Shady Grove Life Sciences Center Parcel 7 (Autolus), Site Plan Amendment No. 81997005B

Request for approval of up to 143,272 square feet of development to construct an 85,000 square foot building for a combination office, lab, and light manufacturing facility and associated parking and landscaping; proposal includes 61,728 square feet of approved but unbuilt density on the Property and a transfer of 23,272 square feet of approved but unbuilt density from 9800 Medical Center Drive per Sec. 59-C-5.321 of the 2004 Zoning Ordinance.

RECOMMENDATION AND CONDITIONS

OVERALL SITE PLAN

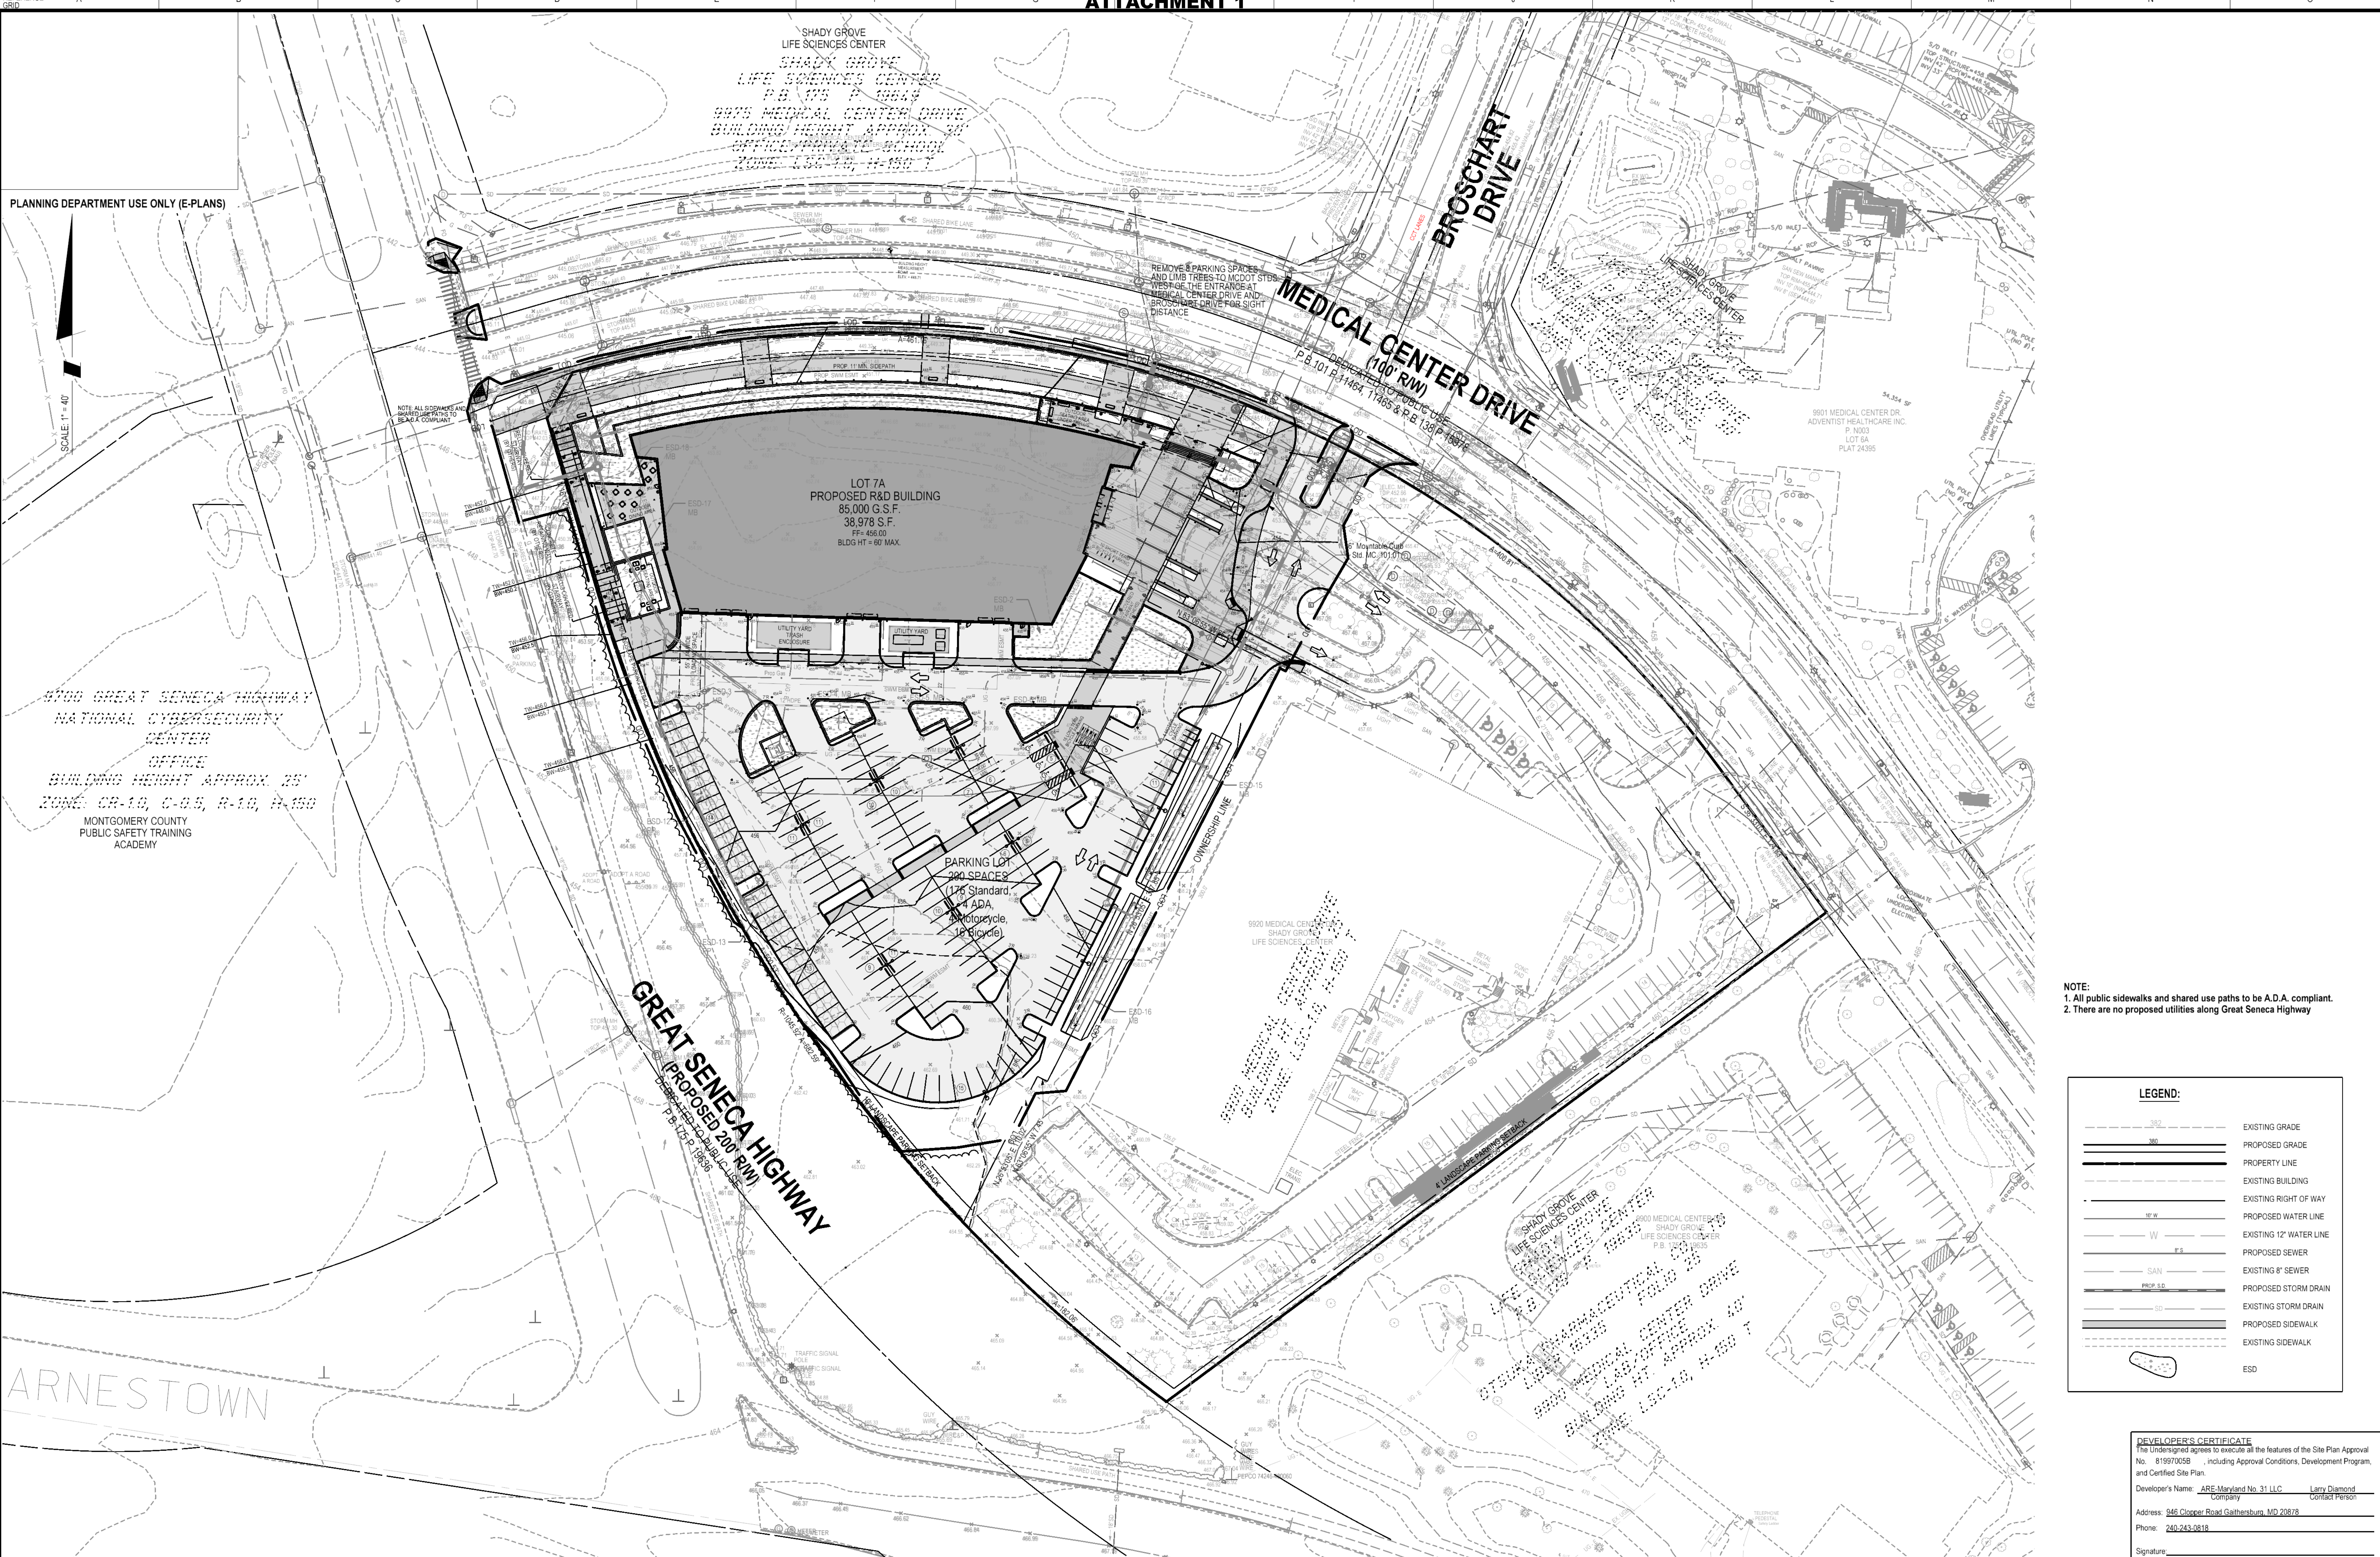
Before approval of the Certified Site Plan the following revisions must be made and/or information provided subject to Staff review and approval:

- c) Show the vehicular entryway with a continuous flush crossing through the median for pedestrians using the five (5)-foot-wide sidewalk, and pedestrians and cyclists using the eleven (11)-foot-wide sidepath.

- d) Show the pedestrian crossing connecting the island adjacent to the handicap parking and long-term bicycle parking to the building's entrance to curb grade as raised, allowing pedestrians to cross without stepping down into drive aisles.

- e) Show the layby area as constructed with non-standard paving to help guide cars through the entryway aisle and into the surface parking lot.
- f) Show short-term bicycle parking spaces via inverted U-racks or a similar design allowing for two points of contact with the bicycle frame.

- g) Show the long-term bicycle parking spaces completely enclosed and anchored to the ground.
- h) Revise the plans to comply with the shower and locker facility requirements of 6.2.6.A.4. and provide no less than three (3) showers and lockers for each gender, totaling no less than six (6) showers and six (6) lockers.
- i) Revise the Final Forest Conservation Plan to include all off-site disturbance.
- j) Add a note stating that “Minor modifications to the limits of disturbance shown on the site plan within the public right-of-way for utility connections may be done during the review of the right-of-way permit drawings by the Department of Permitting Services.”
- k) Modify data table to reflect development standards approved by the Planning Board.
- l) Ensure consistency of all details and layout between Site and Landscape plans.

FINAL FOREST CONSERVATION PLAN
 AMENDED FINAL FOREST CONSERVATION PLAN 81997005B
**SHADY GROVE LIFE SCIENCES CENTER
 PARCEL 7**
 GAITHERSBURG (9th) ELECTION DISTRICT, MONTGOMERY COUNTY, MARYLAND

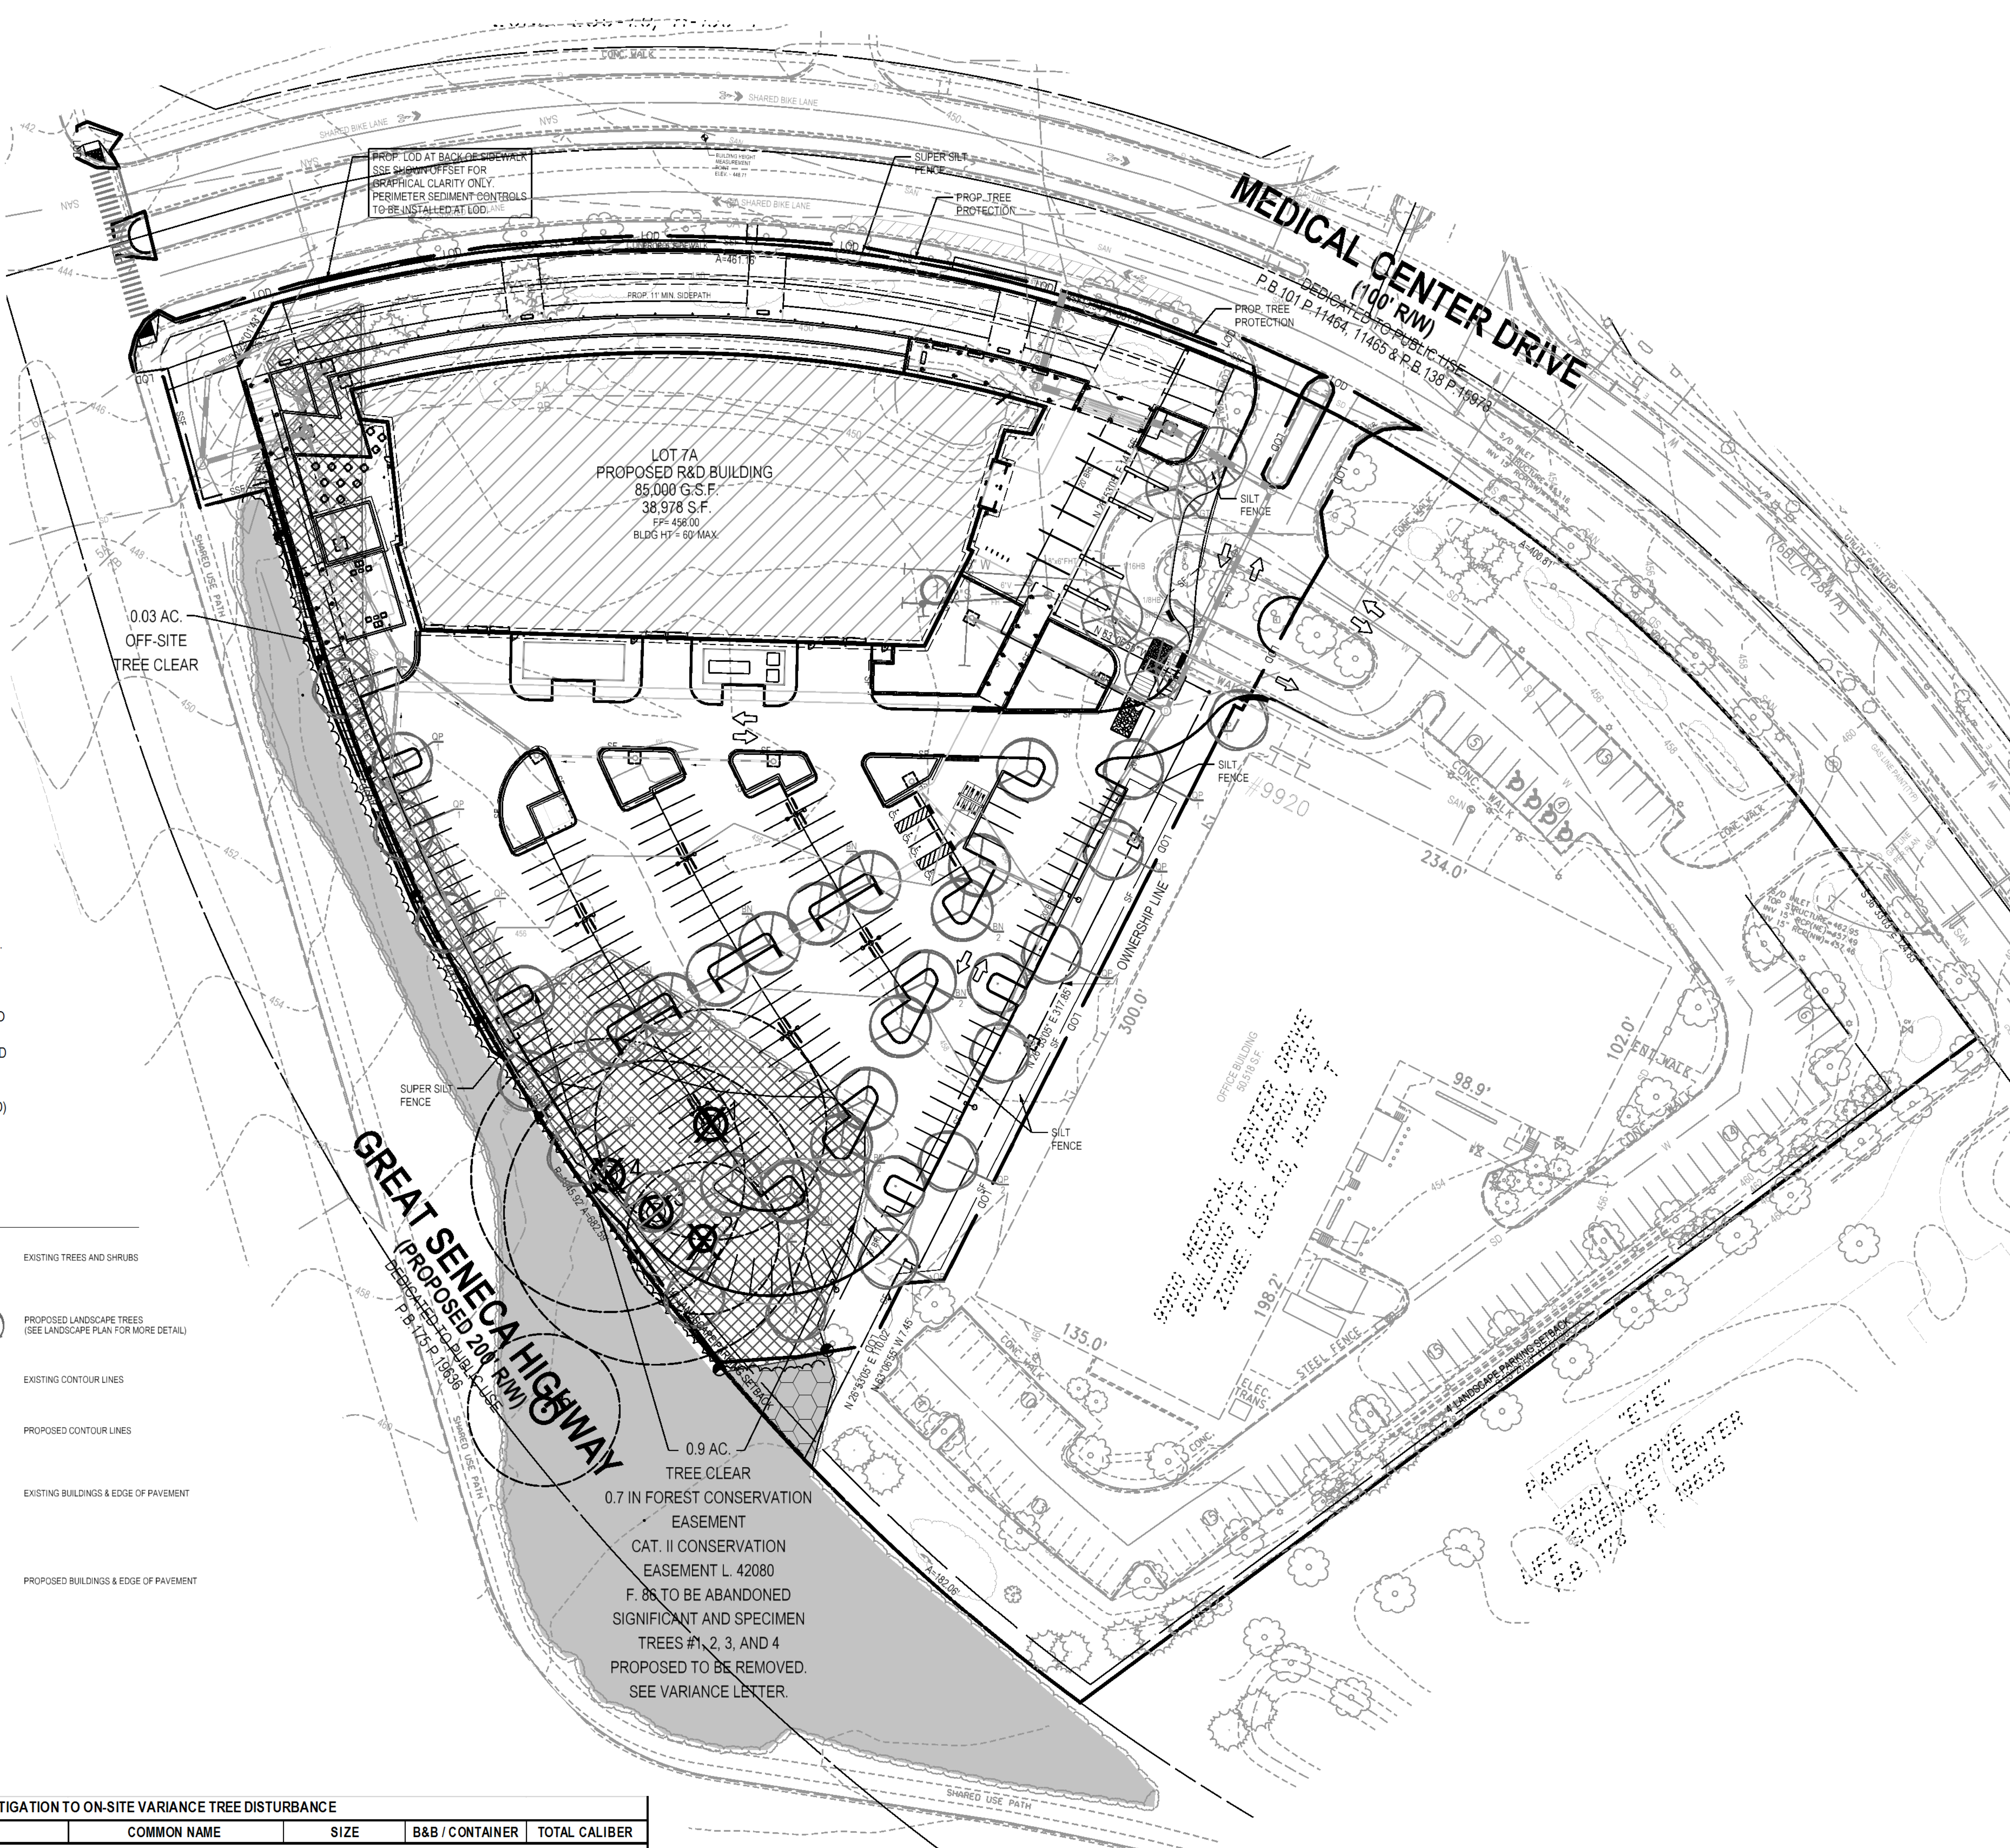
2. The forest conservation plan shows super silt fence along the sidewalk next to the ROW trees that are proposed to remain along Medical Center Drive.
Please revise to locate these sediment control measures, farther from the trees or utilize trenchless methods.
